STATE OF CONNECTICUT *CONNECTICUT SITING COUNCIL* Ten Franklin Square, New Britain, CT 06051 Phone: (860) 827-2935 Fax: (860) 827-2950 E-Mail: <u>siting.council@ct.gov</u> Web Site: www.ct.gov/csc

RE: **SUB-PETITION NO. 1293-HCDREOS-01 (Haddam, Chester, Deep River, Essex and Old Saybrook)**– Eversource Energy declaratory ruling that no Certificate of Environmental Compatibility and Public Need is required for all transmission facility asset condition maintenance improvements statewide to comply with the updated National Electrical Safety Code clearance requirements.

Re: Sub-Petition No. 1293-HCDREOS-01: 1261/1598 Transmission Line Structure Replacement Project, Amendment to Sub-Petition

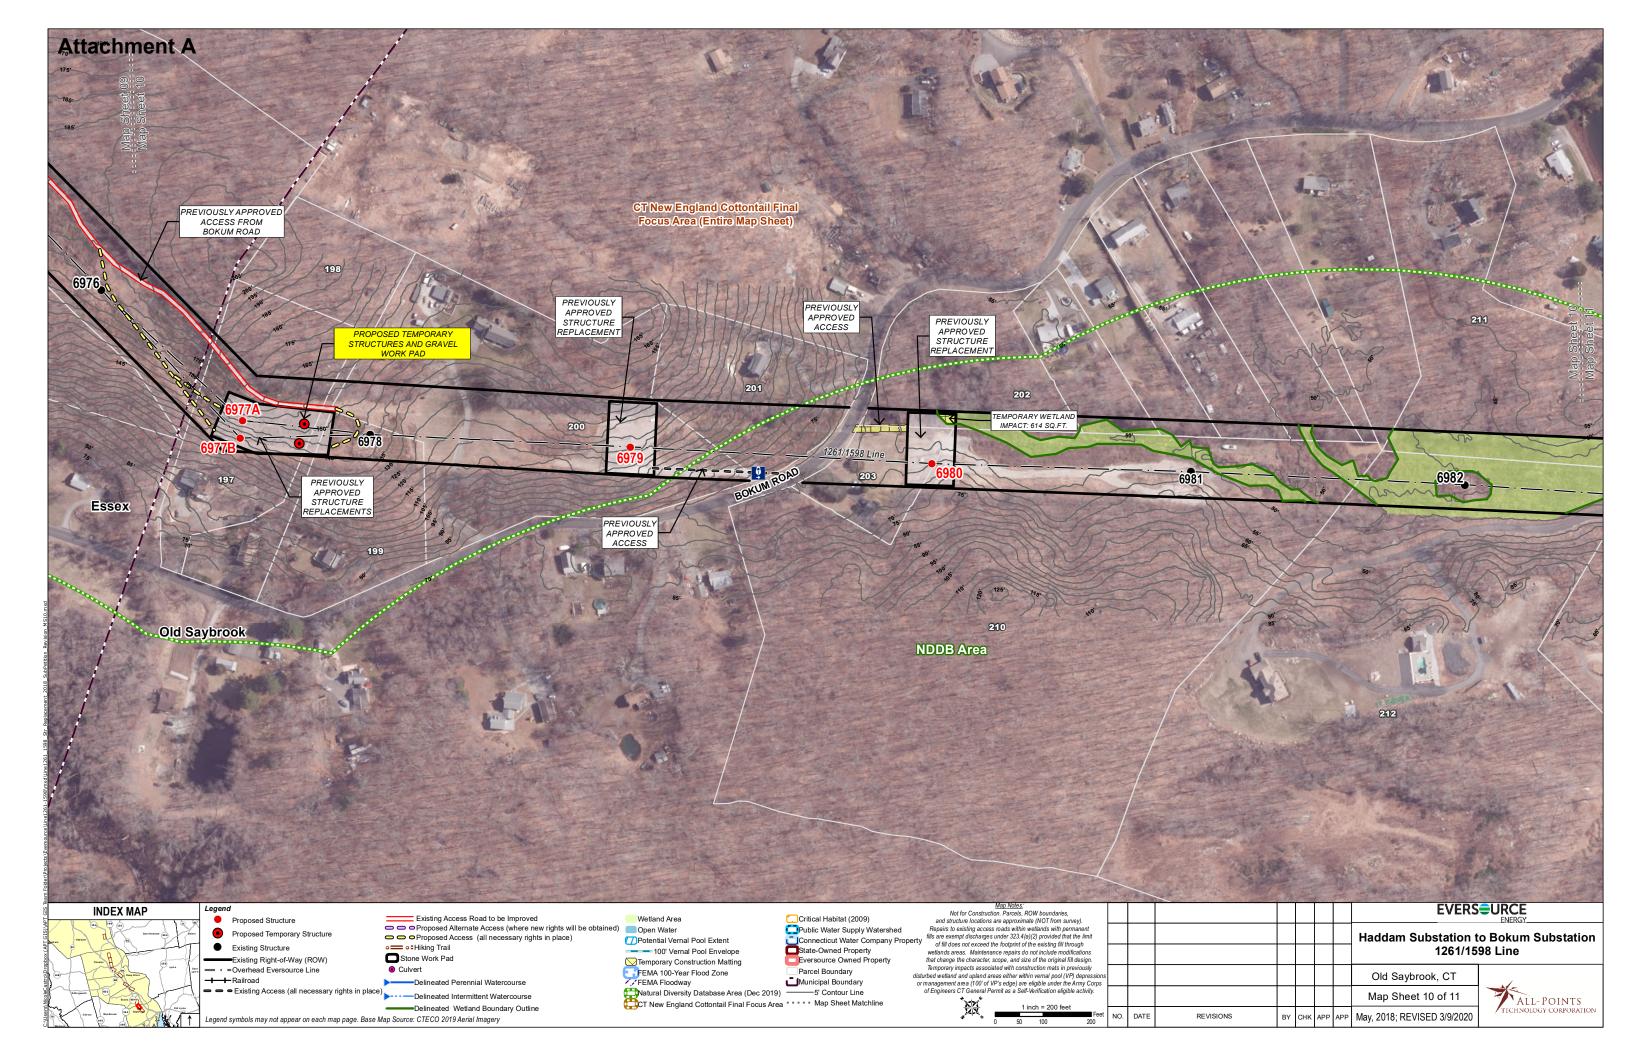
• Install temporary guyed wood pole structures and associated gravel work pad to facilitate replacement of approved Structures 6977A and 6977B in Old Saybrook

The temporary structures will be similar in height to the existing structures and be installed approximately 150 feet southeast from approved Structures 6977A and 6977B within the Eversource ROW and are shown as *"Proposed Temporary Structures and Gravel Work Pad"* on revised Map Sheet 10 dated March 9, 2020 (see Attachment A). The area will be accessed from the approved gravel access road off Bokum Road in Old Saybrook.

Subsequent to the Council's ruling, Eversource re-evaluated the construction approach for the replacement of Structures 6977A and 6977B and determined that the existing guy wires should be removed to enhance the safe access of large construction vehicles and work crews around the base of the structures and more easily facilitate the structure replacement activities. Installation of the temporary guyed structures would relieve tension on existing structures 6977A and 6977B and allow for the

removal of the existing guy wires. Upon completion of the structure replacement activities the temporary structures and guys will be removed, and the area will be restored to its original condition or better.

The proposed minor project change consists of the installation of two temporary guyed wood pole structures and an associated gravel work pad to facilitate replacement of Structures 6977A and 6977B within existing Eversource right-of-way off Bokum Road in Old Saybrook. The temporary wood poles are necessary to relieve tension on the existing structures resulting from the removal of existing guyed structure support wires to accommodate construction vehicle access. The temporary wood poles will be similar in height to the existing structures and will be installed approximately 150 feet southeast of approved Structures 6977A and 6977B. Upon completion of the structure replacements, the temporary structures and associated guy wires will be removed, and the disturbed area restored.

Pursuant to the Council's Petition No. 1293 decision of March 31, 2017 and the June 5, 2018 decision on this sub-petition, your request for the proposed modification is hereby approved.
